City of Pembroke Pines
Planning & Economic Development Department
601 City Center Way 3rd Floor
Pembroke Pines FL, 33025

| Agenda Date: | February 28, 2019 | Application ID: | SP 2018-04 |
| Project: | Chevron Gas Station #358 Improvements | Project Number: | PRJ 2018-05 |
| Applicant Request: | Expansion of existing gas station to adjacent vacant parcel. Updates to existing gas station facility. | | |

JOB # 15039
DWG # C-2.0
SHEET NUMBER

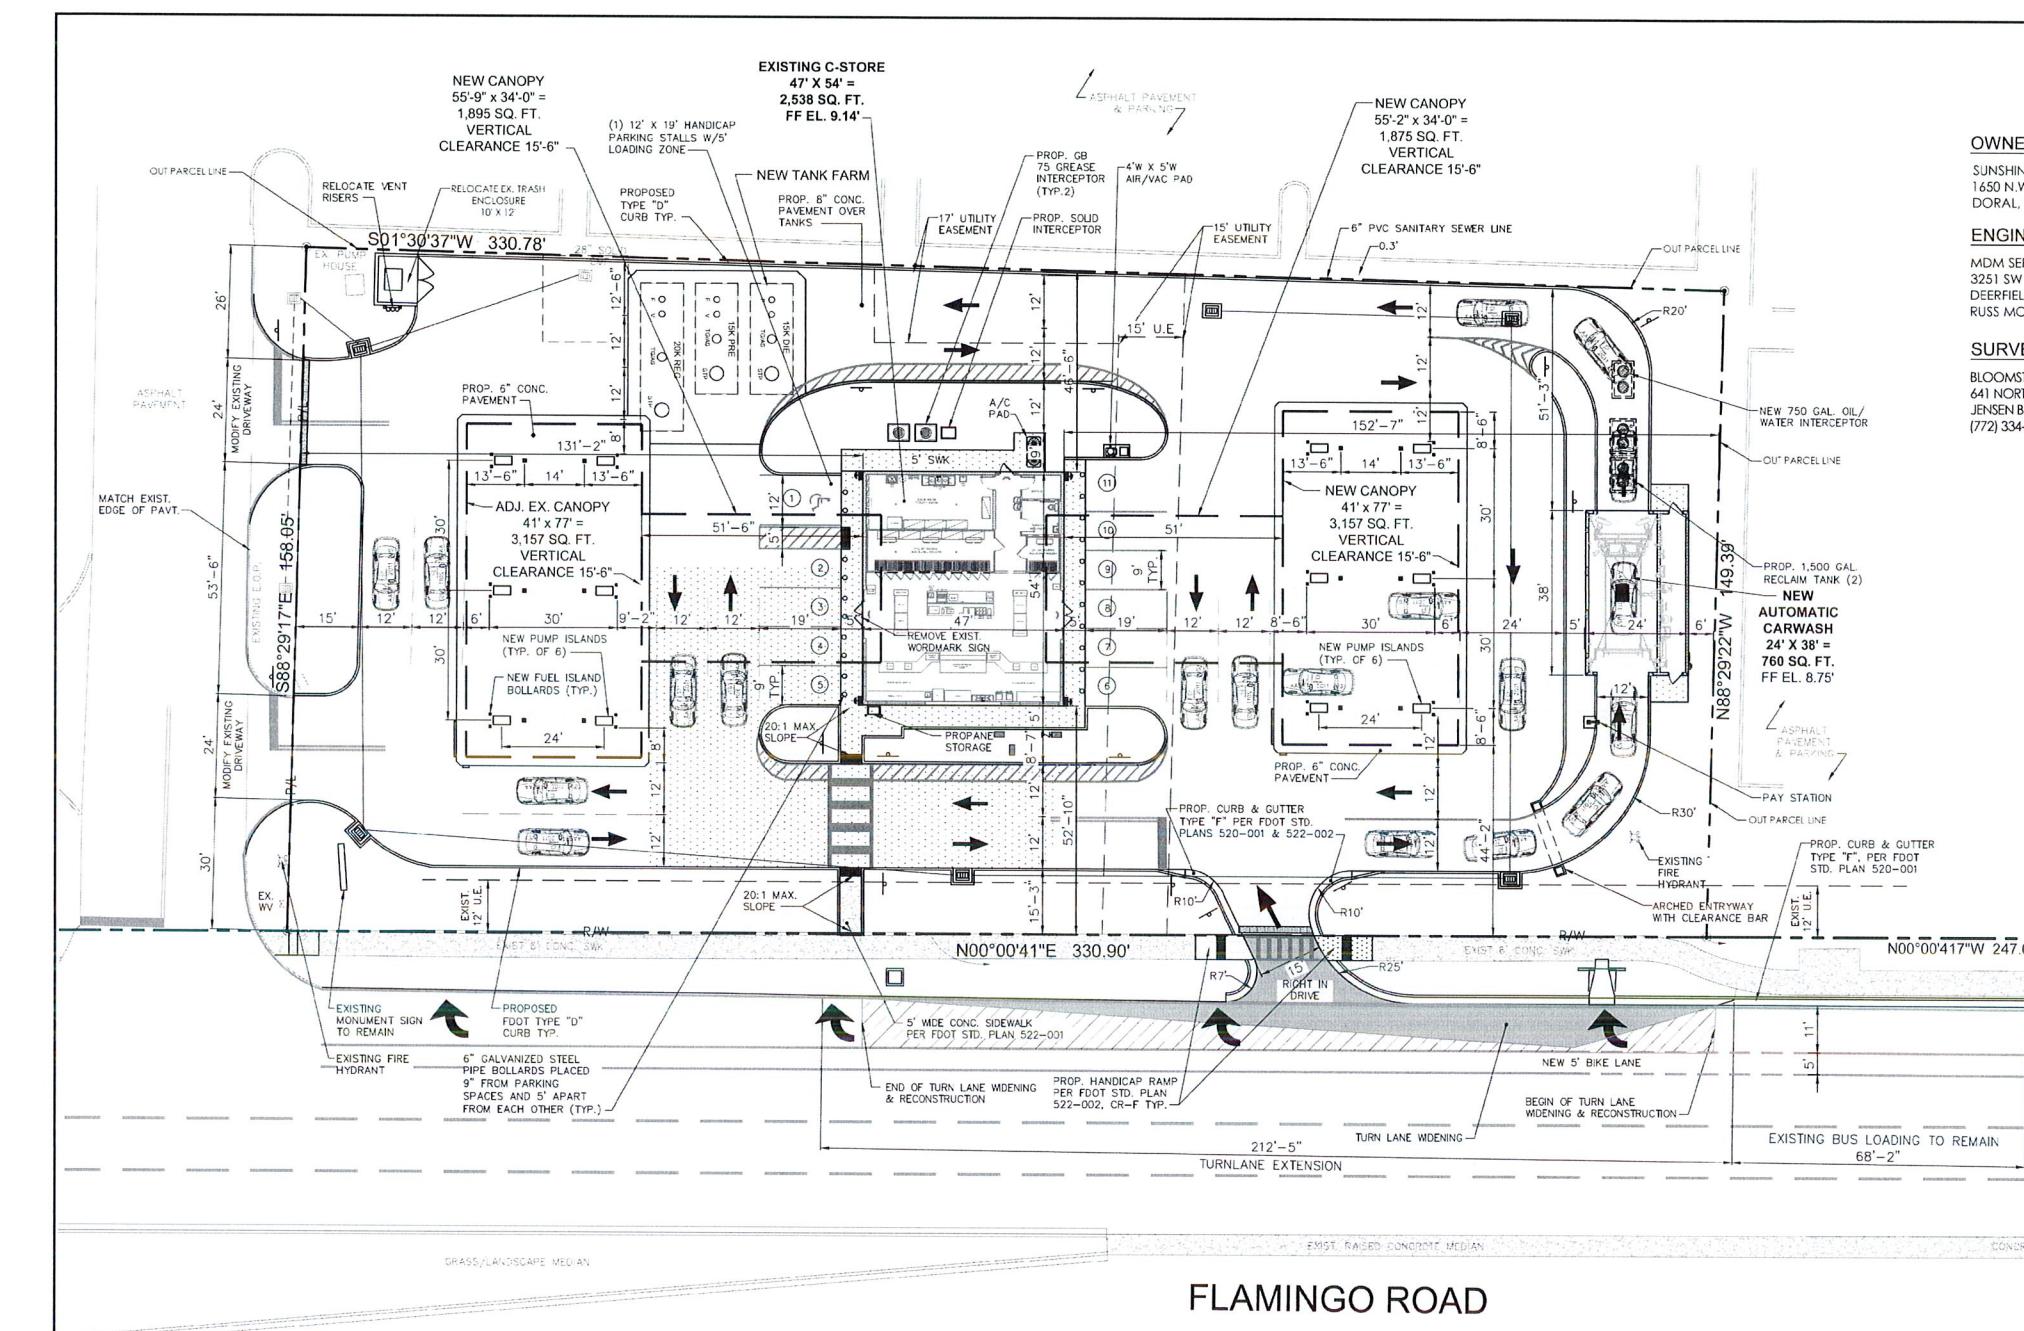
12/14/2018 - New Comment: Staff has concerns with traffic circulation on site, especially going into car wash heading south along east property line as this is in conflict with traffic heading north along this side. Propose alternatives to correct this situation.

21. Provide elevations for Car Wash. Provide stacking for car wash in compliance with Code of Ordinances. Please declare whether car wash is automatic or not. Provide details of any menu sign. For purposes of this review, it is presumed that the carwash is automatic. **Note on plans the carwash is automatic. Provide details of menu sign. Stacking provided is in the opposing drive lane, which is a concern to staff. Please revise.**

RICHARD R. MORRIS
FL REG # 34748
JOB # 15039
DWG # C-2.7
SHEET NUMBER

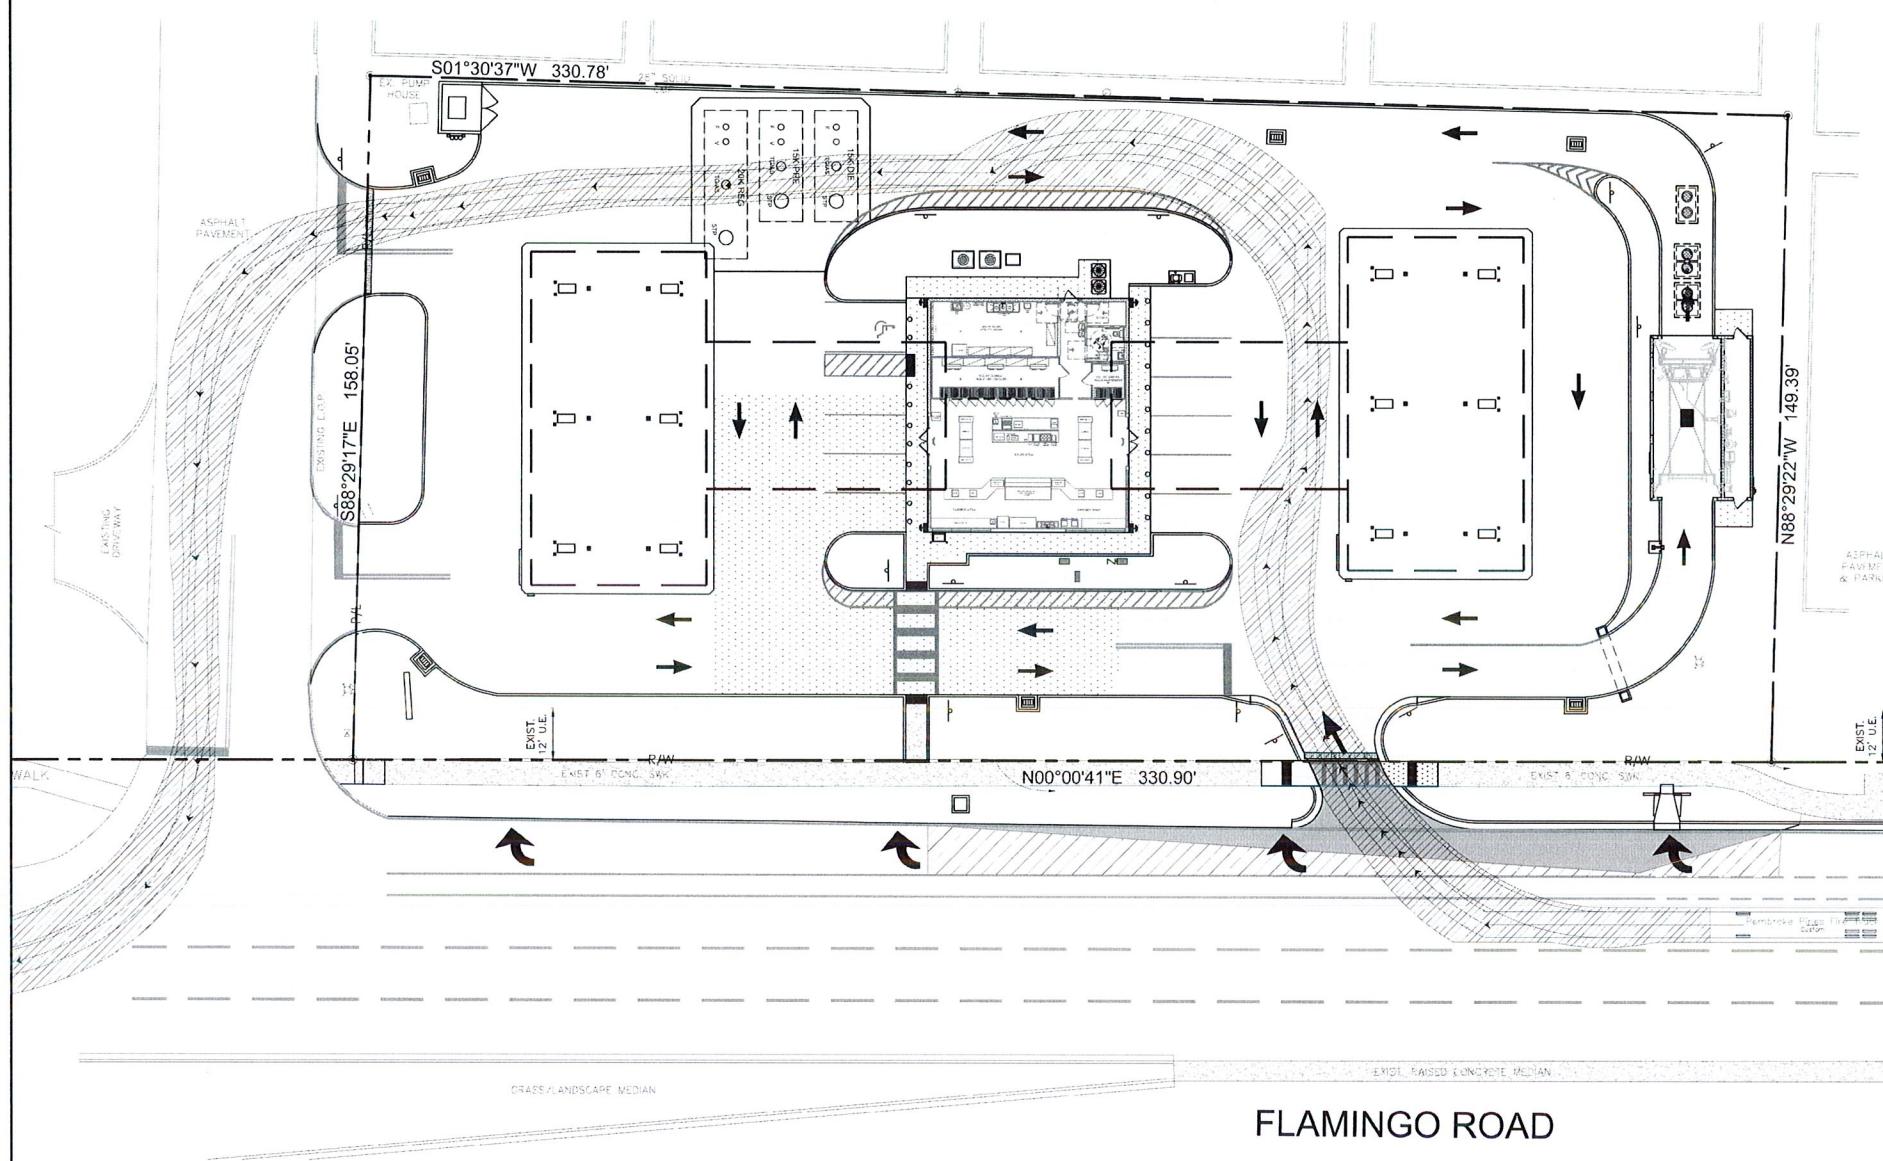
- 1. Please submit full sized (24" X 36") "scaled" drawing to (20, 30, or 40 engineering scale) depicting the required fire access road dimensions and radii into and out of the entire site (including the mall areas). Also, you must provide a "shaded" fire truck access route on a separate sheet.**

- b) Depict on the plan fire access traveling in a north bound direction (**into the Right in Drive as shown on Sheet C-2.0**) from S. Flamingo Rd. and turning east into the plaza (see attached file, depicted in red). Note, the fire access plan must depict our Fire Department Vehicle **Entering and Exiting** through the site.**

- d) Note, that all fire access roads shall be a minimum centerline turning radius of 50'. Show min. 38' inside radius and min 62' outside radius throughout area. Show a shaded truck route including entering and leaving the site with the above turning radius numerals on plans shown throughout. *COPP Engineering department verification is required. COPP CO 154.35 (3)***

10. Provide the City Fire required 'Typical 20' Wide Shaded Fire Access Route' throughout the proposed project site with the 38' inside, 50' centerline and 62' outside radii depicted and noted along the route. Recommend providing on a separate plan sheet for clarification and City Fire review use. Recommend revising the drawing name for Sheet C-2.7 to 'Fire Truck Autoturn Plan', which will allow for the added plan (Sheet C-2.8) to be named 'Fire Truck Access/Route/Path Plan'.

PHOTOMETRIC PLAN
SCALE: 1' = 30'-0"

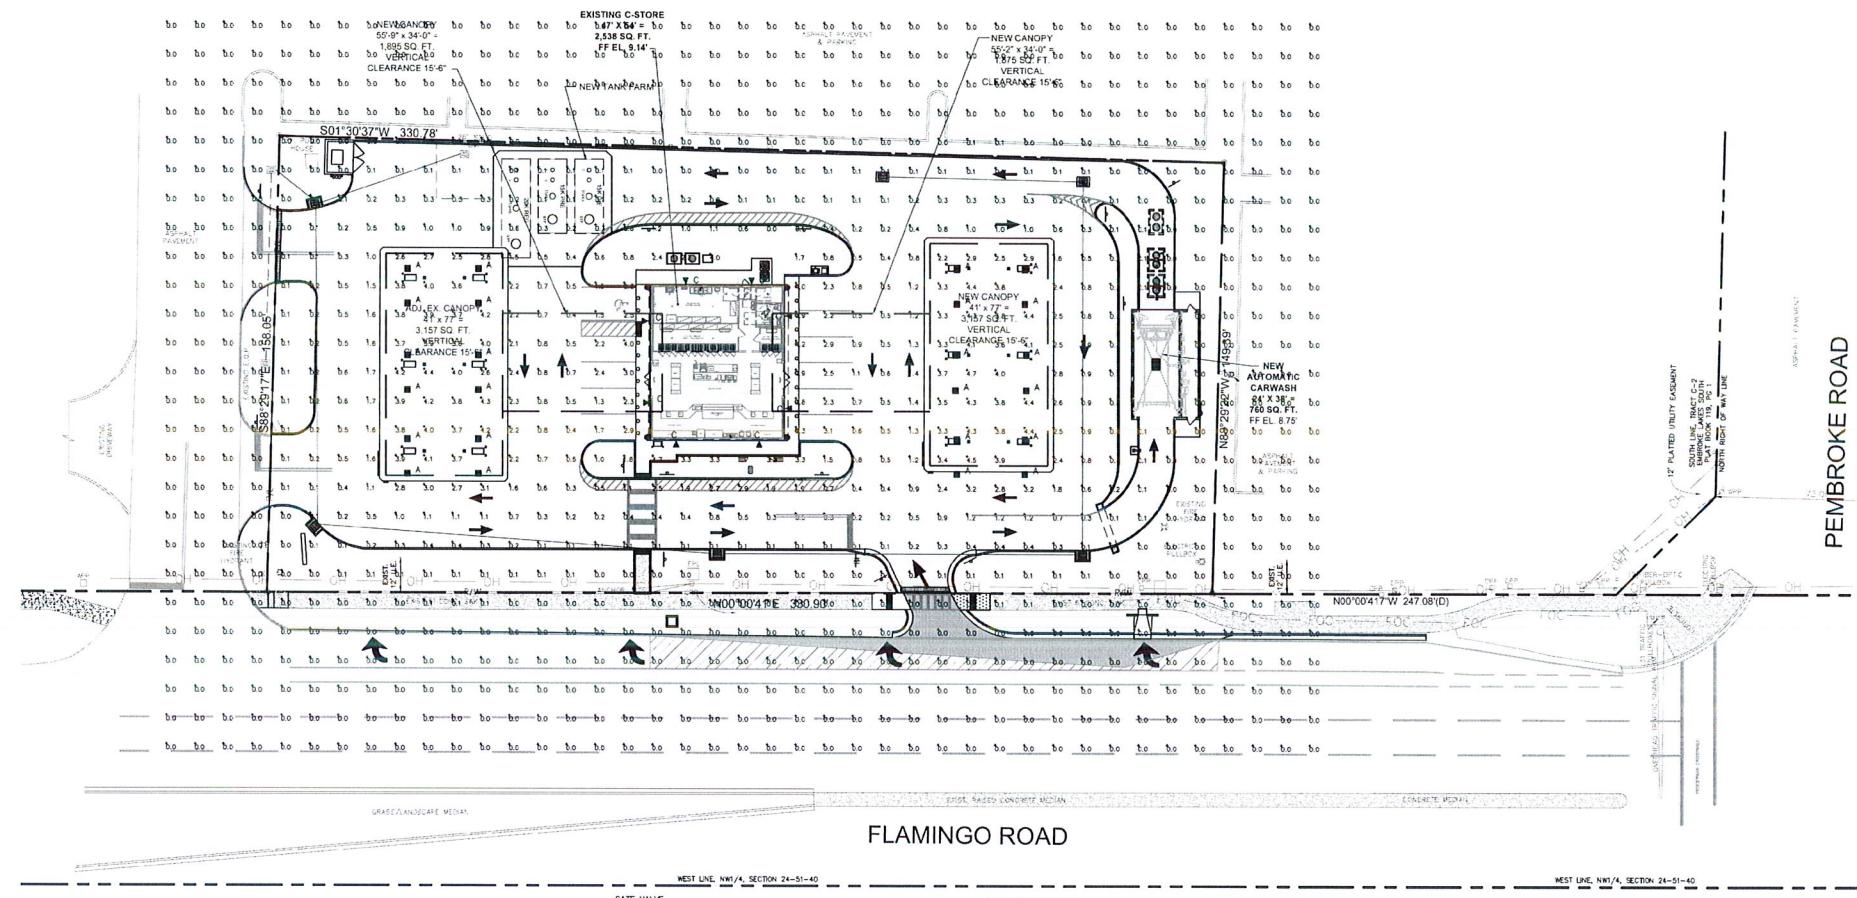
13. Provide "heat" level of fixtures to show they meet code maximum of 4,000 K's.

Not provided. Provide details/notes on plans showing maximum of 4,000K.

14. Provide light detail/cut sheet for fixtures under canopy to show they are recessed with full cut off fixtures.

Acknowledged in response letter, however, add note(s) on plans stating this.

19. Photometrics exceed Code. Please review Section 116 of the Code of ordinances.
20. All new under canopy lights must be recessed. Staff requests that the applicant consider recessing existing lighting for consistency purposes. **Note on plans that existing as well as new canopy lighting will be recessed.**

FIXTURES UNDER CANOPY ARE RECESSED WITH
FULL CUT OFF

05 NORTH ELEVATION - CANOPY ELEVATIONS
SCALE: 1/8"=1'-0"

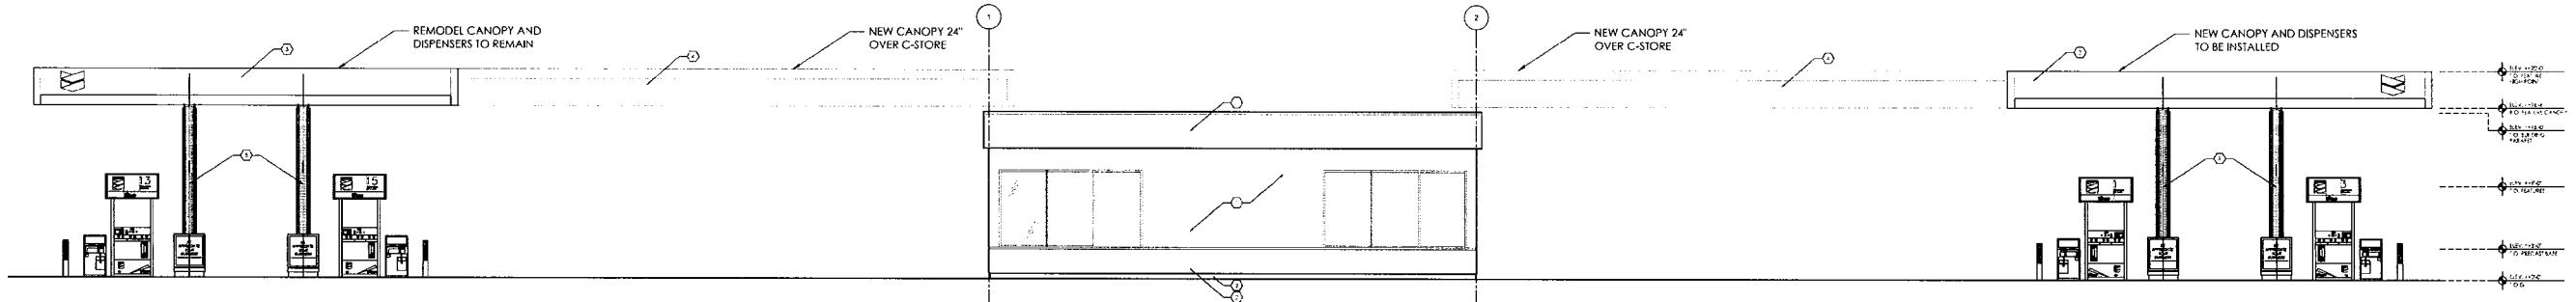
1. Provide all details, dimensions, location(s), etc. of all building signs, monument signs, etc.
Still need details of all signage on building/canopies. As new canopy has Chevron logo, additional signs are included and all details need to be provided to show additional signage still meets code.

12/14/2018 – Comment addressed that no signage is being provided. However, this comment remains as elevations of canopies show Chevron logos which are considered signage, any existing building signs need to be accounted for, monument sign on site needs to be accounted for and confirm there is not additional signage on convenience store and/or car wash building. All of these signs need to be included in master sign chart showing dimensions, square footage, etc.

8. ~~Provide all details, dimensions, location(s), etc. of all building signs, monument signs, etc.~~
Still need details of all signage on building/canopies. As new canopy has Chevron logo, additional signs are included and all details need to be provided to show additional signage still meets code.

18. Do you plan on lighting the canopy exterior or features on canopy exterior? If so please identify how this item is being illuminated. Illuminated features may be considered signage. **Provide details of canopy signage and the illumination.**
